AGENDA

**STAFF REPORT
KETCHUM PLANNING AND ZONING COMMISSION
MEETING OF JULY 16, 2026**

GREYHAWK TOWNHOMES

L2.11 ACCESS + FIRE DEPT

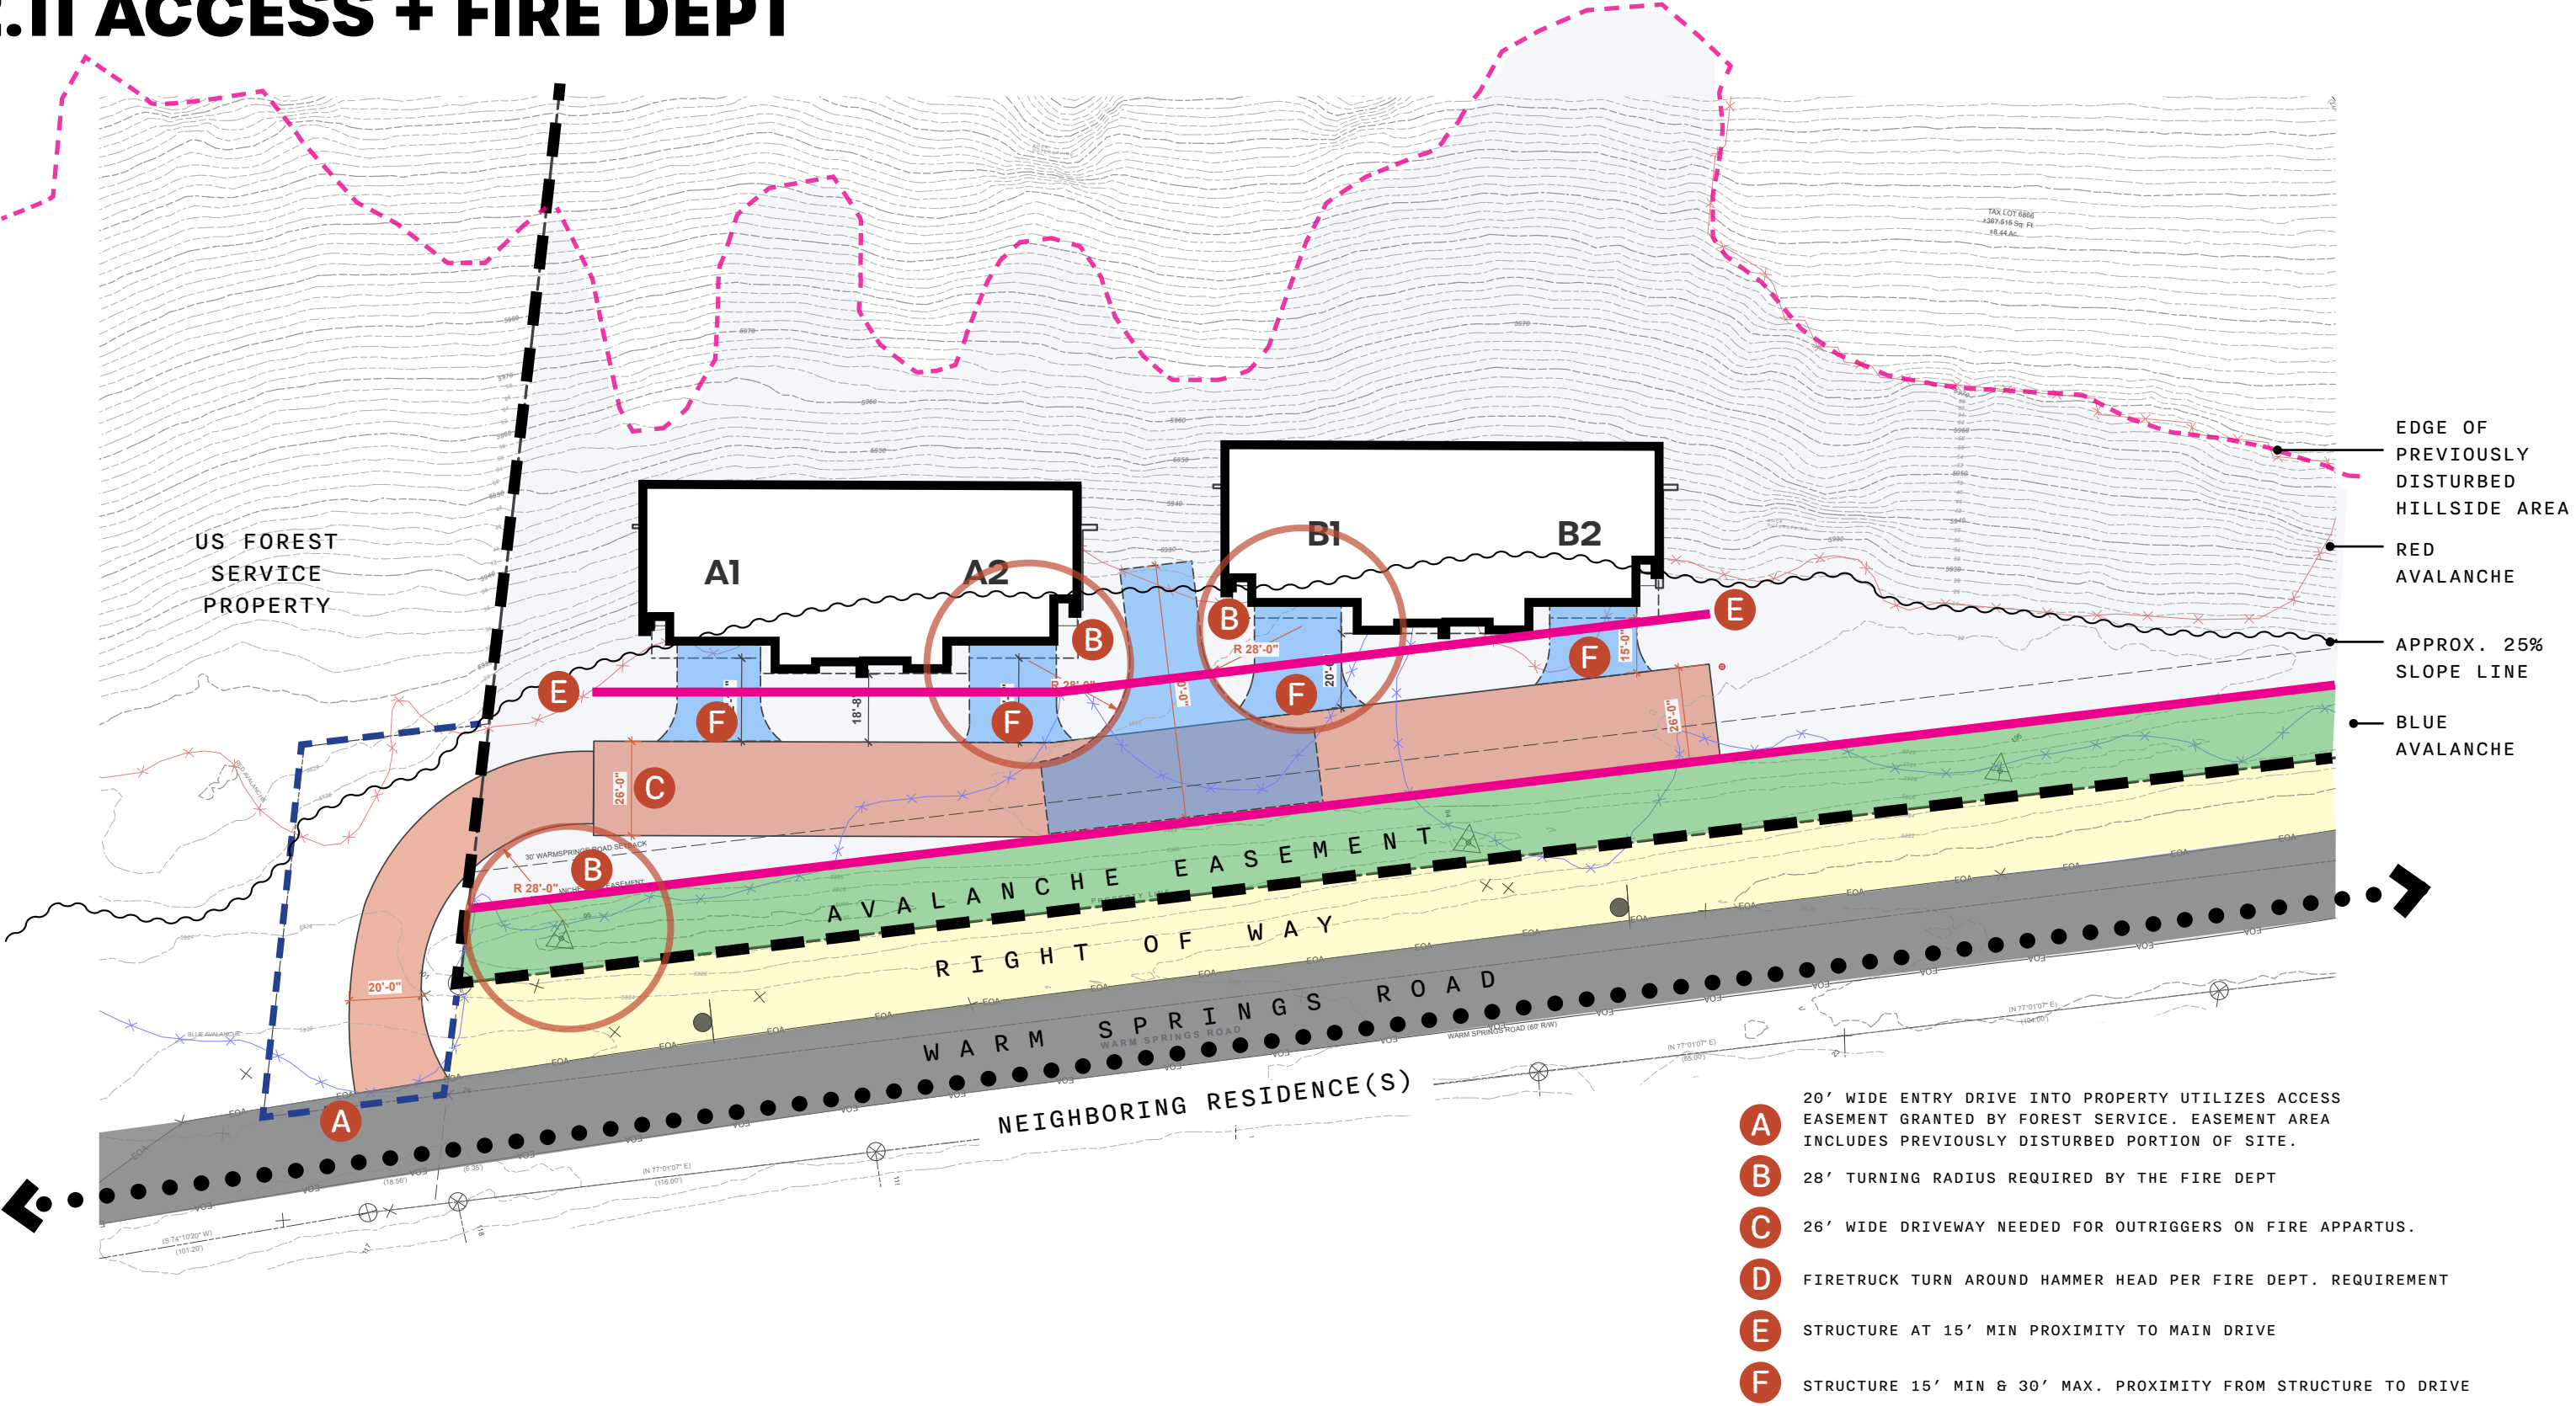
In addition, the City Engineer has noted that the required 28-foot turning radius shown on Sheet L2.11 may have flexibility to shift closer to the avalanche easement. Refinement of the access drive geometry, together with corresponding adjustments to the placement of Building A while maintaining required fire separation distances, may further reduce encroachment into the hillside.

BUILDING A - WEST ELEVATION

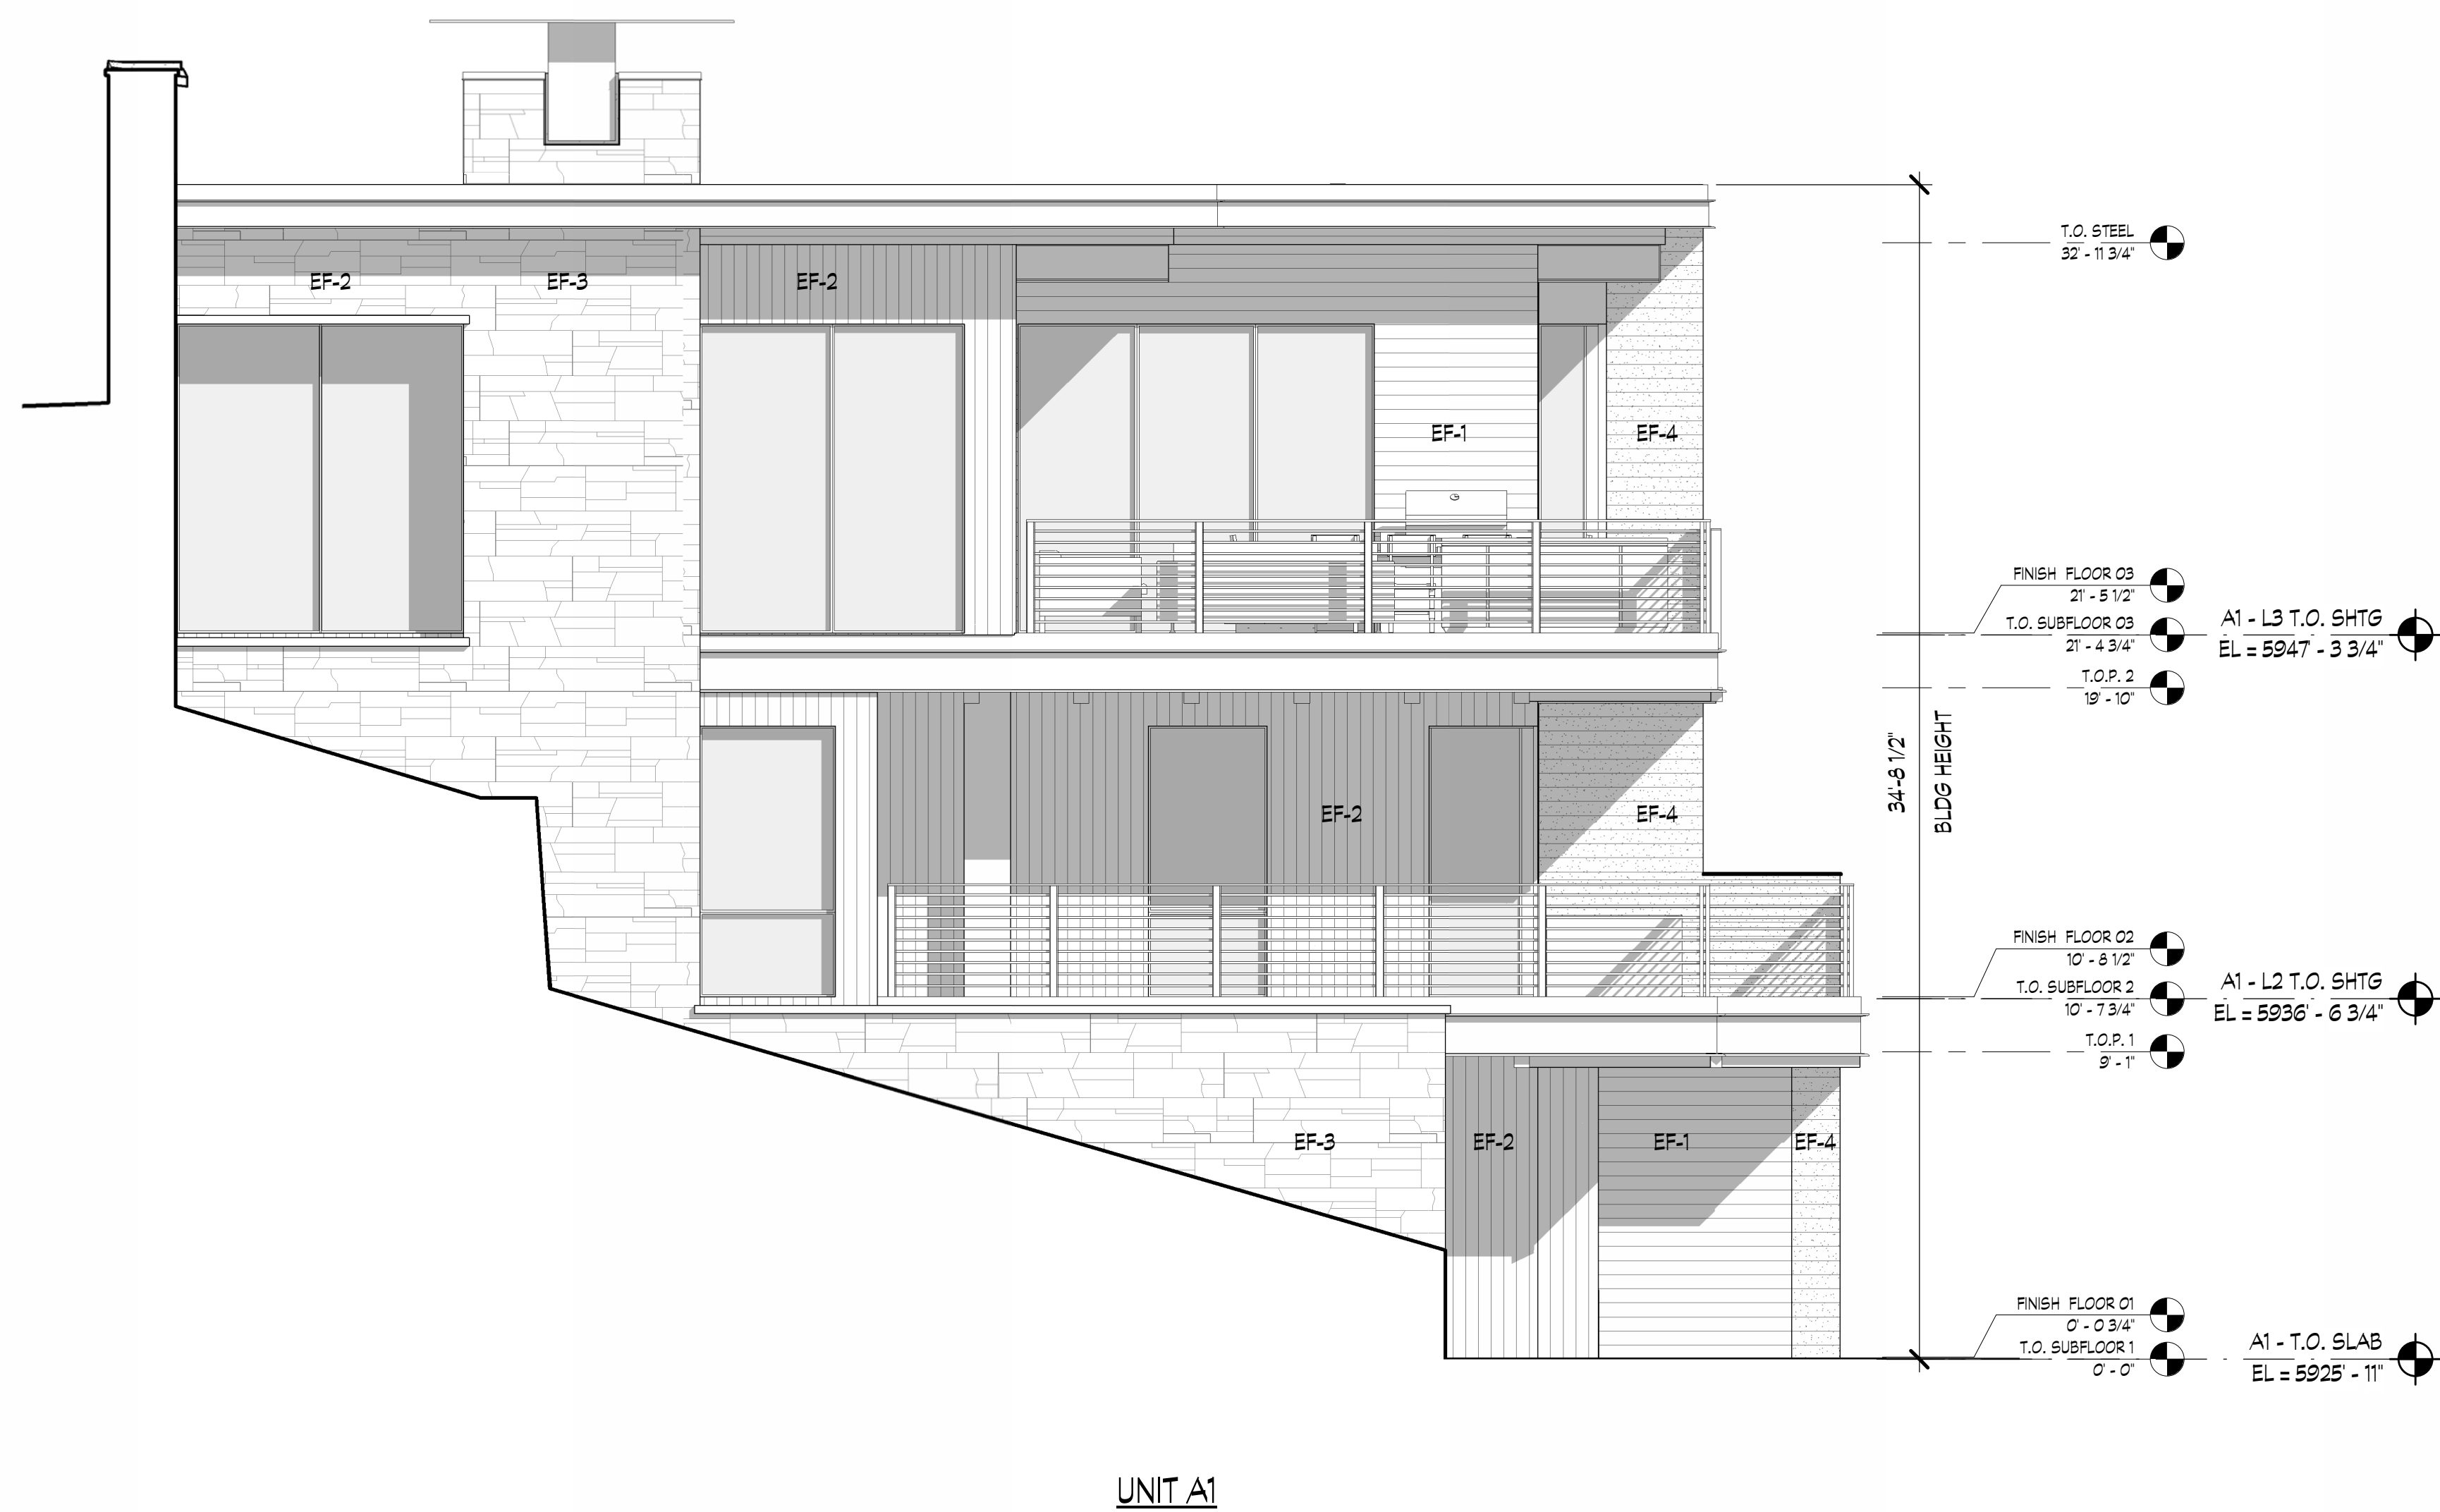
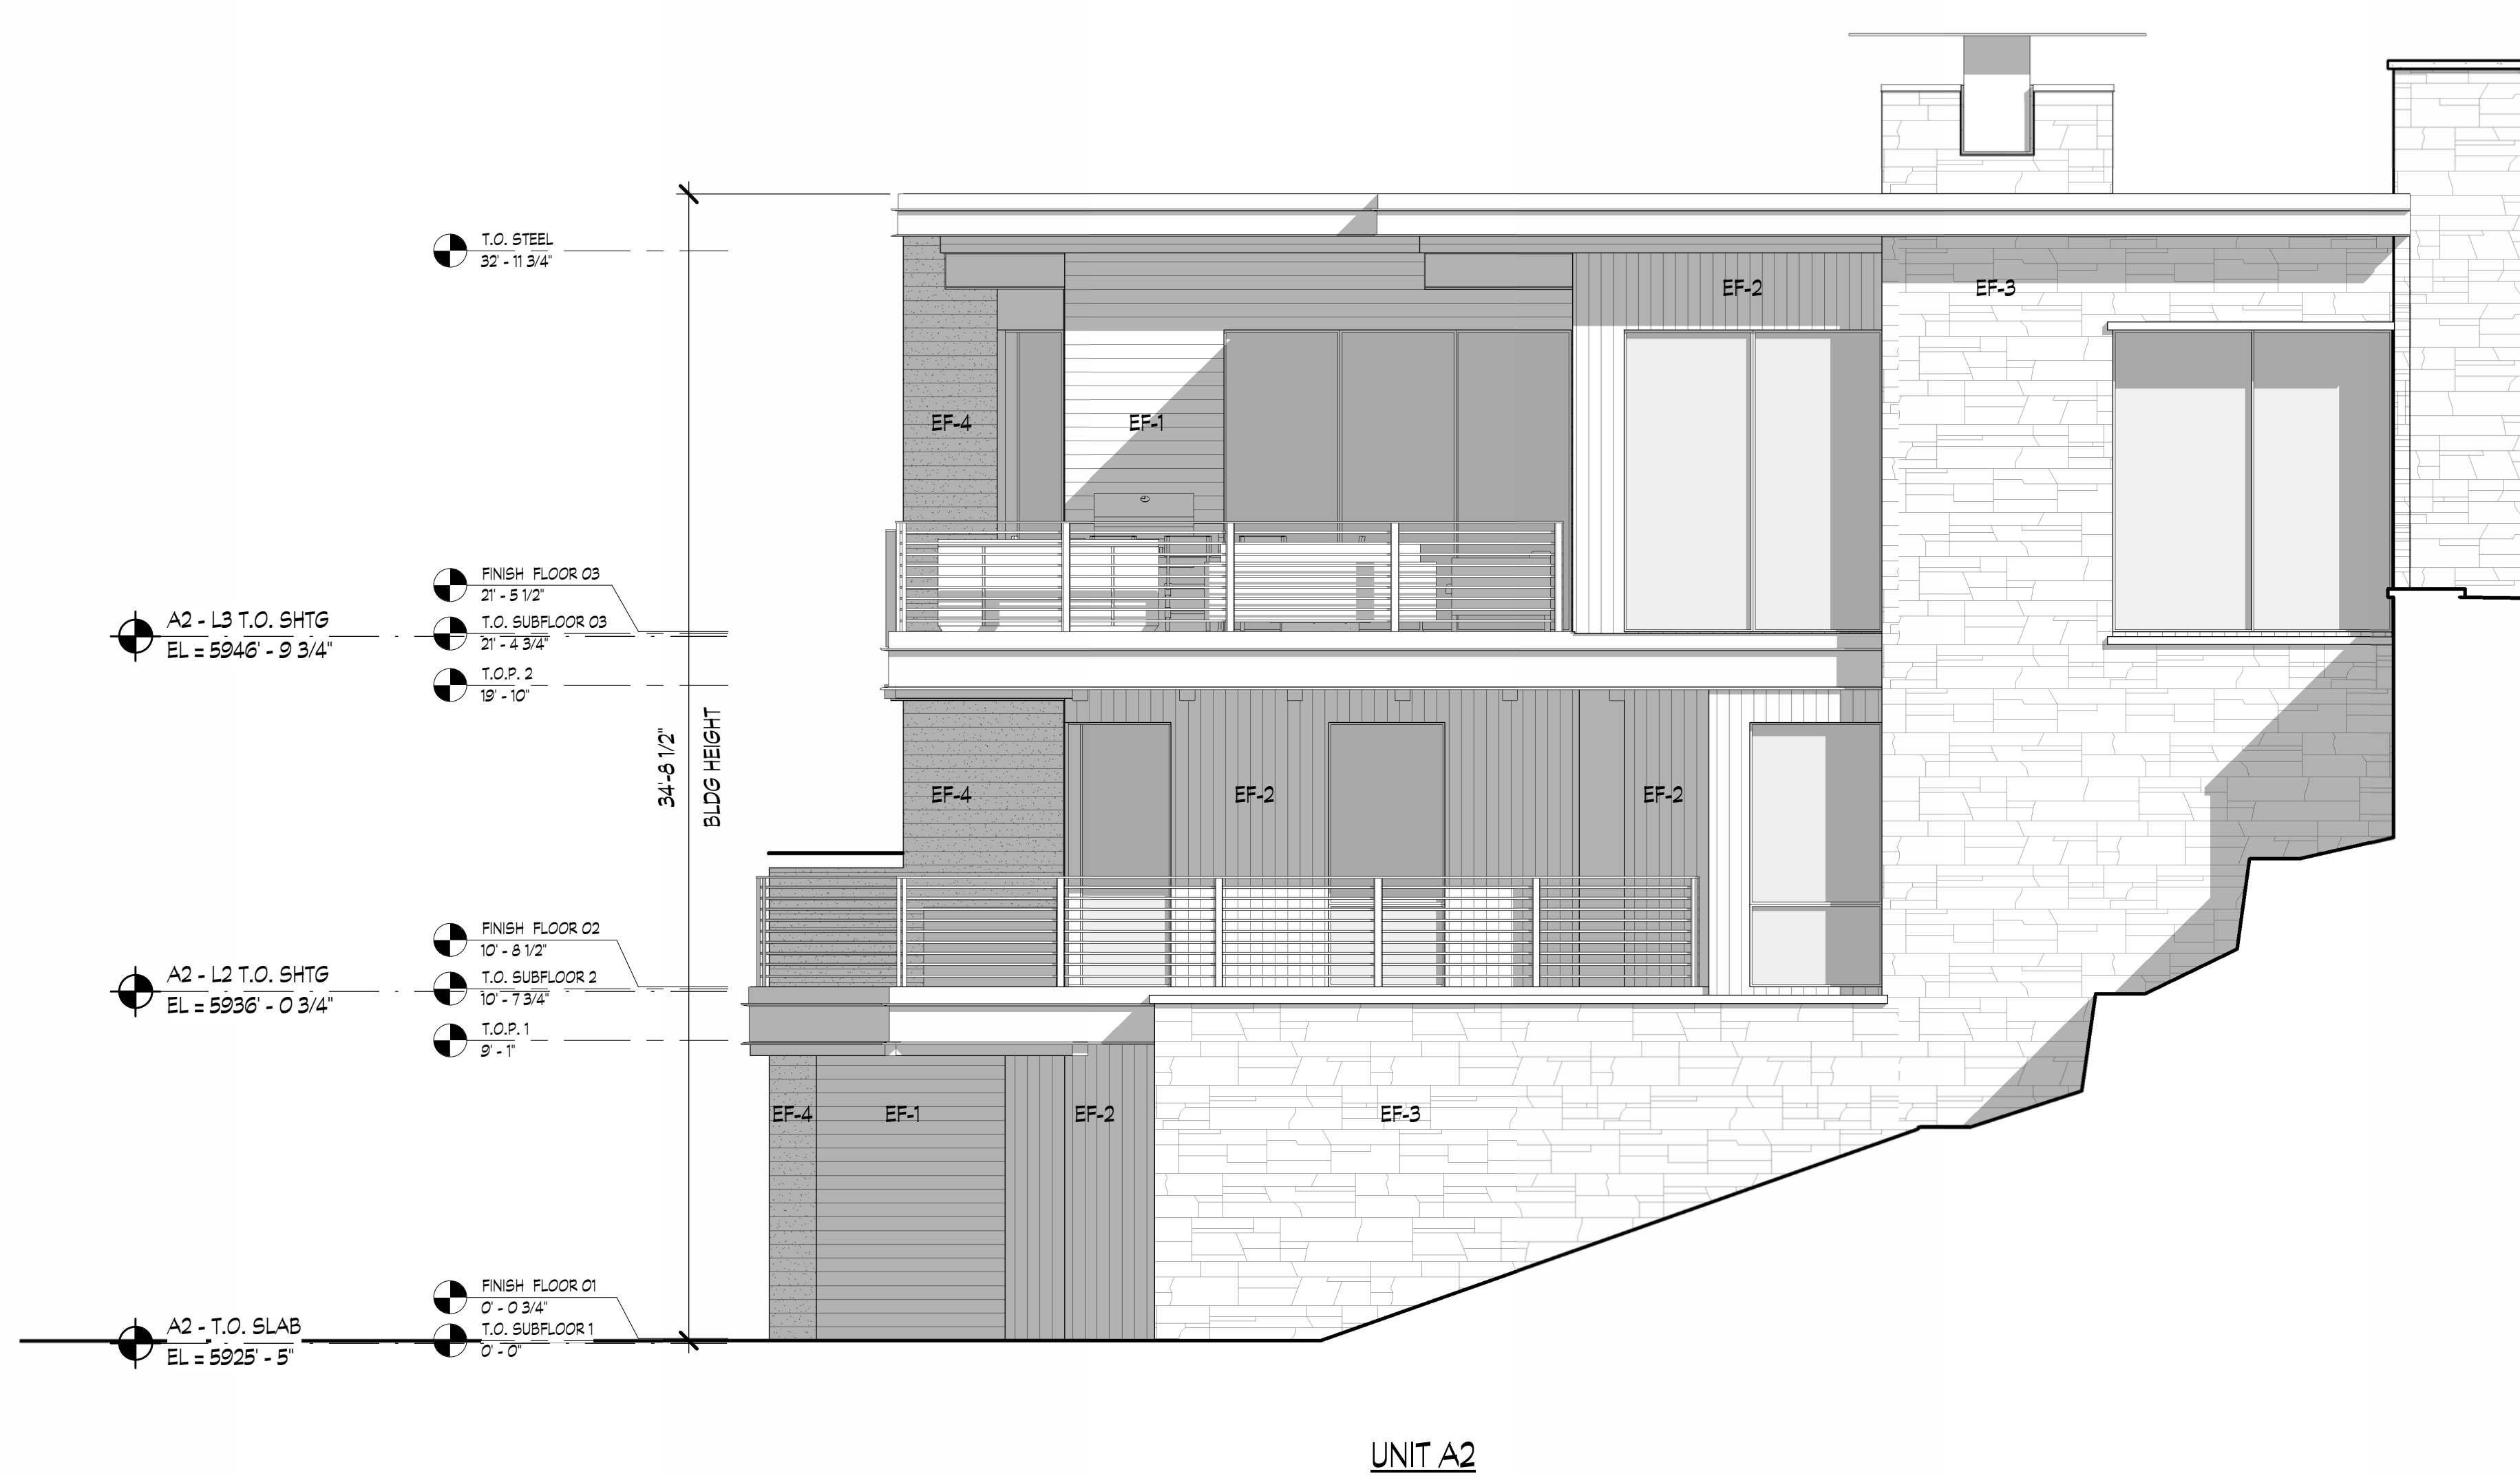
The submitted building elevations (Sheets A-312 and A-322) indicate that building height has been measured to the top of the flat roof. However, pursuant to the definition of Building Height in LDC §16.08.020, building height must be measured from the lowest of natural, existing, or finished grade to the highest point of the structure, including parapets and other roof elements. Based on the submitted plans, staff cannot verify compliance because the rear avalanche protective wall appears to be the highest point of the structure but is not included in the building height calculation. Prior to final Mountain Overlay Design Review, the applicant should revise the building height calculations to measure to the highest point of each structure in accordance with LDC §16.08.020.
